3. N. High Street Renovations 25-015MPR

Minor Project Review

Proposal: Request for review and approval for renovations of three existing buildings in the Historic District that will be utilized as retail and office space. The 0.71-acre site is zoned HD-HC, Historic Core District.

Location: 72 and 84 N. High Street, 20 North Street

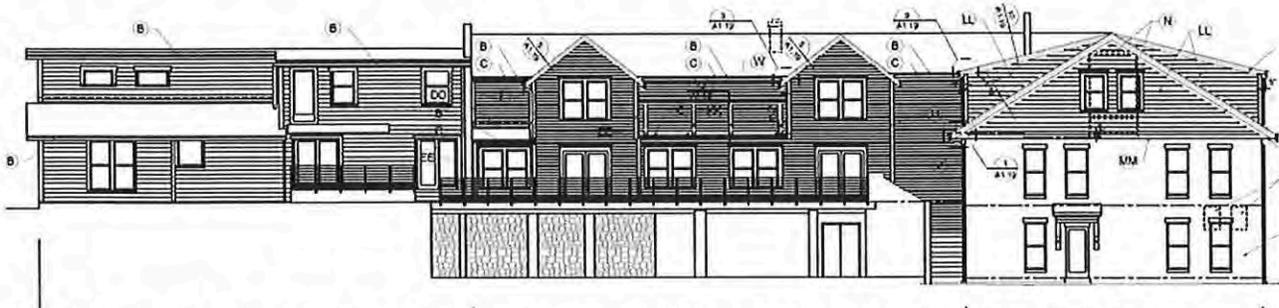
Ms. Holt referenced the above rendering of 72/84 North High Street to detail proposed renovations. The left side has new windows and doors and will retain the stone. The center portion has the signature feature box bay windows that are treated uniquely from the rest of that portion of the building. There are single hung windows, special trim detail and drop siding that will match the siding found underneath the plywood skin. This will be clad in 4-inch reveal lap siding. On the right

side, 7" horizontal siding will be used. There are new windows and doors. The gable and box bay detail has been simplified, which is appropriate for this newer section of the building. A rendering from the river was shown for reference.

Ms. Holt stated that this left side is largely hidden by 20 North High Street. It has the wider horizontal siding and new windows and doors but not a lot of changes. In the center, the stone foundation remains. It has narrow horizontal siding, adjusted windows and doors, and a new HVAC screening area. On the right section, windows have been added to help balance the façade. The existing air conditioning units are all going behind the centrally located HVAC screen. A new doorway is added with a shed roof feature and the top floor is going to have siding and new windows. The stucco will remain on the lower floors. Other elevations are largely unchanged and not visible. Staff is satisfied with the proposed changes as made by applicant.
